UNITED STATES PATENT AND TRADEMARK OFFICE

APPLICATION NO.	FILING DATE	FIRST NAMED INVENTOR	ATTORNEY DOCKET NO.	CONFIRMATION NO.
10/664,288	09/17/2003	L. Mercer McKinley	101896-206 (DEP5129)	4546
21125	7590	08/25/2008	EXAMINER	
NUTTER MCCLENNEN & FISH LLP WORLD TRADE CENTER WEST 155 SEAPORT BOULEVARD BOSTON, MA 02210-2604				ARAJ, MICHAEL J
ART UNIT		PAPER NUMBER		
3733				
			NOTIFICATION DATE	DELIVERY MODE
			08/25/2008	ELECTRONIC

Office Action Summary	Application No.	Applicant(s)
	10/664,288	MCKINLEY, L. MERCER
	Examiner	Art Unit
	MICHAEL J. ARAJ	3733

DETAILED ACTION

Figure 1 (taken from '519)

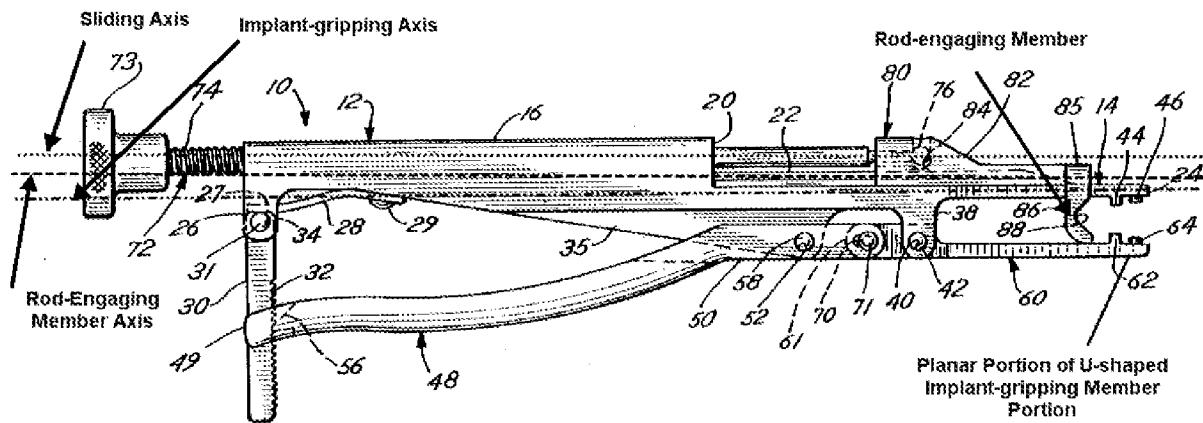
Hayes et al. disclose a spinal rod approximator system(Fig. 6) comprising a spinal implant (2) having a rod-receiving member; and a spinal rod approximator having an implant-gripping member (14) having a u-shaped distal portion (see Figure 2 below) that extends in a direction substantially transverse to a longitudinal axis (A) of a proximal portion of the implant-gripping member, where the distal portion includes opposing legs (44, 46) extend under a distal end of the rod receiving member of the spinal implant (2) formed on a substantially planar U-shaped distal portion; a rod-engaging member (83) slidably coupled to the implant-gripping member along the longitudinal axis of the proximal portion at a position proximal to the implant-gripping member, comprising of opposed arms (86) each having a rod-receiving recess (88), slidably coupled to the implant-gripping member along the longitudinal axis of the proximal portion at a position proximal to the implant-gripping member, the rod-engaging member having a distal portion that extends transverse to a proximal portion (see Fig. 4); and a pusher member (73) freely-rotatably coupled to at least one of the

implant-gripping member and the rod-engaging member and threadably mated to the other one of the implant-gripping member and the rod-engaging member such that the rotation of at least a portion of the pusher member is effective to move at least one of the implant-gripping member and the rod-engaging member with respect to one another. The pusher member comprises a threaded rod extending through a threaded bore formed in a portion of the implant-gripping member, and wherein the threaded rod includes a distal end mated to a portion of the rod-engaging member and includes a handle member. The rod-engaging and implant-gripping members are offset from the sliding axis (as seen in Fig. 1 below).

Figure 2 (enlarged portion of Figure 1)

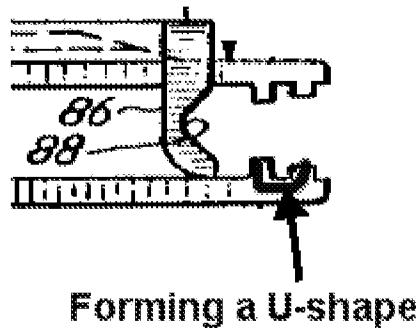
Applicant's arguments filed May 1, 2008 have been fully considered but they are not persuasive. Applicant argues that Hayes et al. does not disclose a u-shaped distal portion that includes opposed legs that extend under a distal end of a roe-receiving member of the spinal implant. Firstly, the U-shaped distal portion can be better seen in Figure 2 above. Secondly, depending on how one establishes a distal end of the rod-receiving will clearly show how Hayes et al. reads on the pending claims. Looking at Figure 6, the arrow labeled as 60 can be considered the distal end of the rod-receiving member of the spinal implant. With this definition it is apparent that Hayes et al. does teach a u-shaped distal portion that includes opposed legs that extend under a distal end of a rod-receiving member of the spinal implant.
